June 22, 2005  
RC-05-0090

Subject: VIRGIL C. SUMMER NUCLEAR STATION  
DOCKET NO. 50/395  
OPERATING LICENSE NO. NPF-12  
LICENSE AMENDMENT REQUEST  
REACTOR COOLANT SYSTEM – HEATUP/COOLDOWN CURVES

**LICENSE AMENDMENT REQUEST  
TECHNICAL SPECIFICATION 3/4.4.9 AND ASSOCIATED BASES**

PROPOSED TECHNICAL SPECIFICATION CHANGES (MARK-UP)

Figure 3.4-2 V. C. Summer Unit 1 Reactor Coolant System Heatup Limitations  
(Heatup rates up to 50 and 100 °F/hr) Applicable for the First 32 EFY  
(Without Margins for Instrumentation Errors)

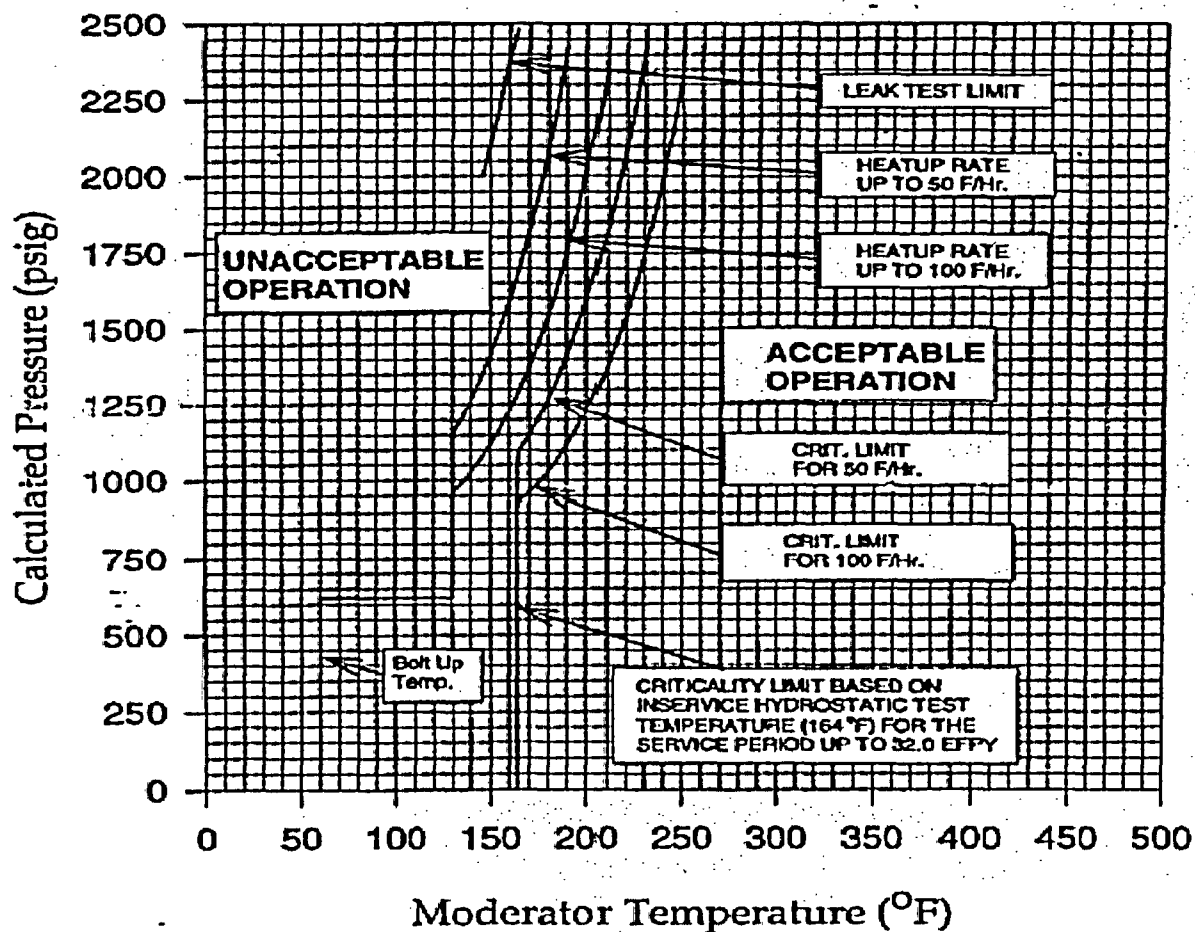
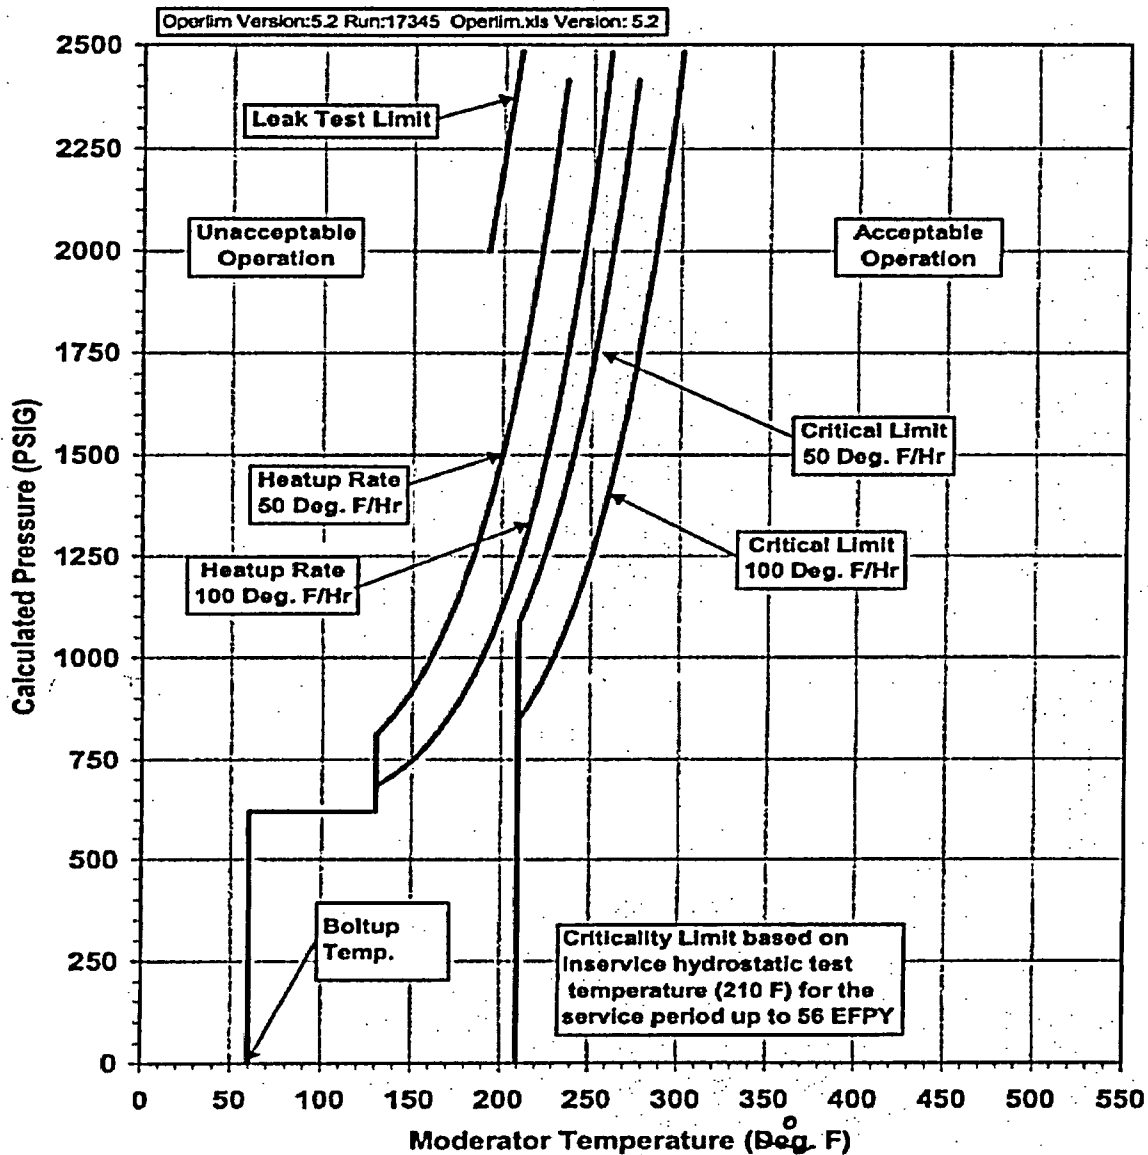
These figures provide the VCSNS Reactor Coolant System heatup and cooldown limitations. The proposed changes incorporate the latest available reactor vessel information and updated calculated fluences, and also extend the applicability of the figures up to 56 EFPY. These proposed curves are more limiting than those currently contained in the TS.

<u>Page</u>	<u>Affected Section</u>	<u>Description of Change</u>	<u>Reason for Change</u>
3/4 4-31	Figure 3.4-2	Replace heatup curve	Revised P/T limits based on analysis of reactor vessel surveillance capsule.
3/4 4-32	Figure 3.4-3	Replace cooldown curve	Revised P/T limits based on analysis of reactor vessel surveillance capsule.
B3/4 4-6	B3/4.4.9	Added updated design basis information.	Revised ASME Code reference.
B3/4 4-14	B3/4.4.9	Deleted unnecessary information contained with in Bases section and updated applicable Bases information.	Correct reference for P/T limit curves.

Replace with  
new Figure 3.4-2

**MATERIAL PROPERTY BASIS:** Limiting Material: Intermediate Shell Plate A9154-1  
Limiting ART Values @ 56 EFPY: 1/4T: 153°F, 3/4T: 138°F

Unit 1  
Figure 3.42V. C. Summer Reactor Coolant System Heatup Limitations (Heatup Rates of 50 and 100°F/hr) Applicable for 56 EFPY (Without Margins for Instrumentation Errors) Using 1998 Appendix G Methodology

FIGURE 3.4-2 V. C. Summer Unit 1 Reactor Coolant System Heatup Limitations (Heatup Rates of 50 and 100°F/hr) Applicable for 56 EFPY (Without Margins for Instrumentation Errors) Using 1998 Appendix G Methodology

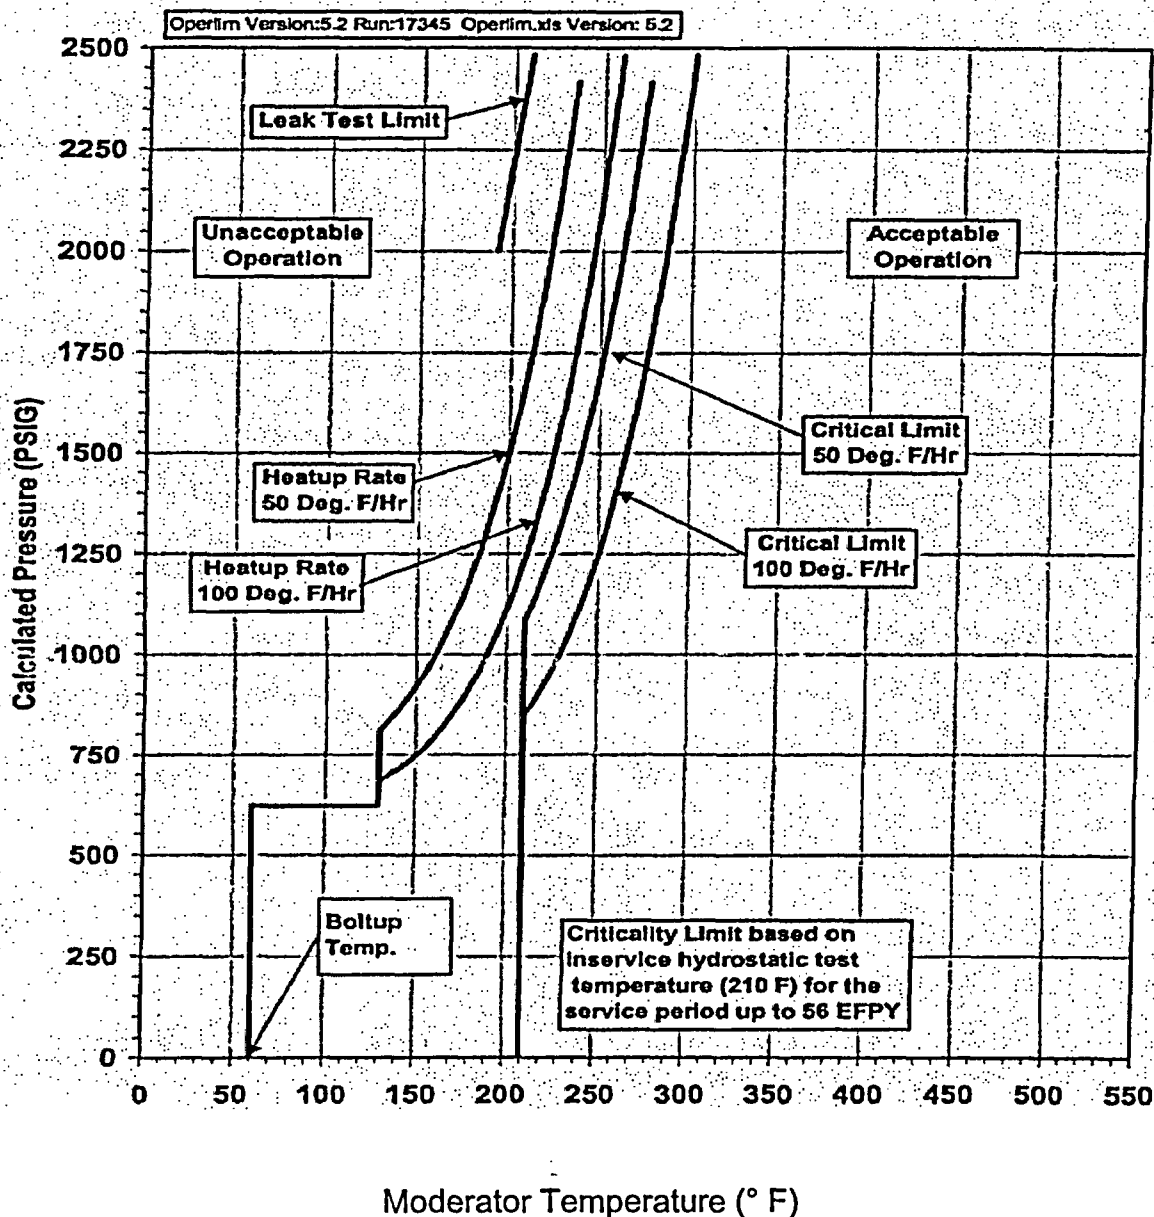
- a) Update Figures 3.4-2 and 3.4-3 to incorporate the latest available reactor vessel analysis and updated calculated fluences. The figures are applicable up to 56 Effective Full Power Years (EFPY).
- b) Revise Bases 3/4.4.9 to delete outdated information and provide revised information applicable to the updated heatup/cooldown curves. The outdated information is being deleted and the revised information is contained in the referenced Westinghouse Topical Report. It was determined that this level of technical data is not required in the VCSNS TS Bases.

LIMITING MATERIAL: INTERMEDIATE SHELL PLATE A9154-1

LIMITING ART VALUES @ 56 EFPY: 1/4T, 153°F

3/4T, 138°F
